rotecting a National Treasure

Bypass Bridge: Design & impacts to the Cabrillo Bridge & California Building

Bertram Goodhue's original rendering

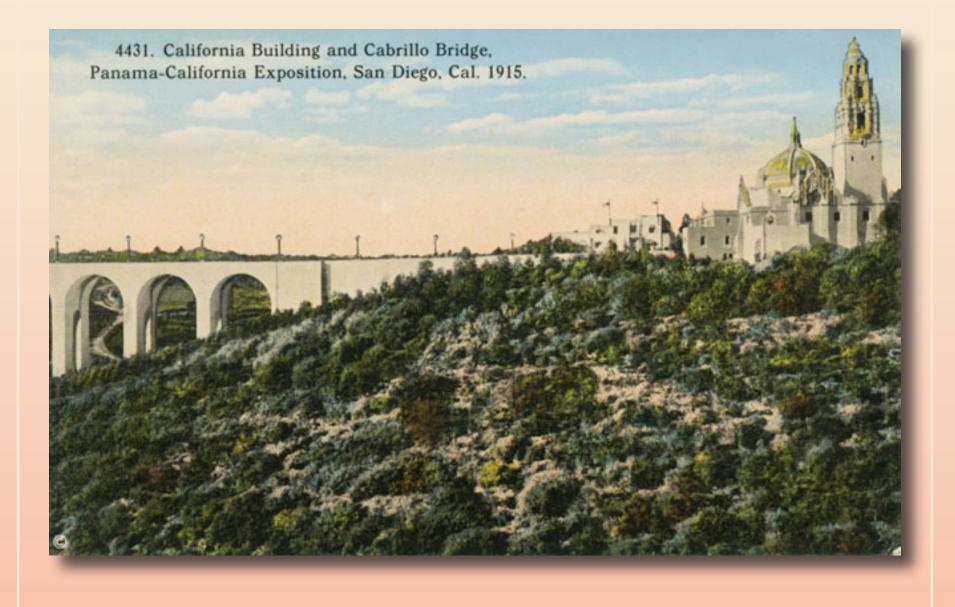
- Any bridge across the face of the Museum of Man auxiliary buildings is unacceptable and is contrary to the Secretary of Interior's Standards for the Treatment of Historic Properties.
- Front and center to the entrance of the historic core of Balboa Park is the wrong location
- It would destroy the whole relationship of the original concept of the City on the Hill
- It would destroy historic fabric with over 84 feet of the original Cabrillo Bridge rail to be removed
- It would destroy or obscure some of the most important character defining features of the El Prado historic district.

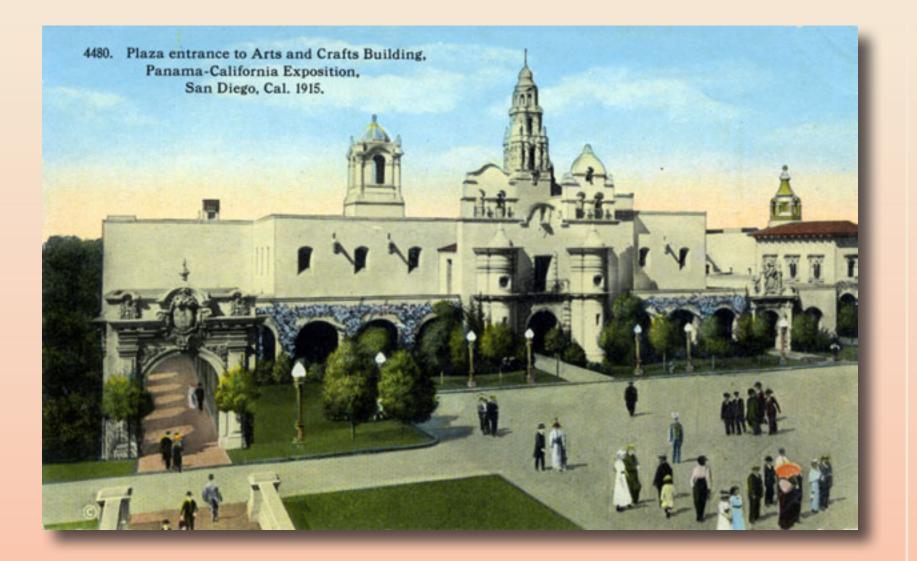
We agree with this goal of the design team but not the method.

- This can be done immediately without building a bridge by removing, pruning and trimming out the overgrowth of the area.
- This area simply hasn't been maintained over the years, it's a simple, quick and cost effective fix.
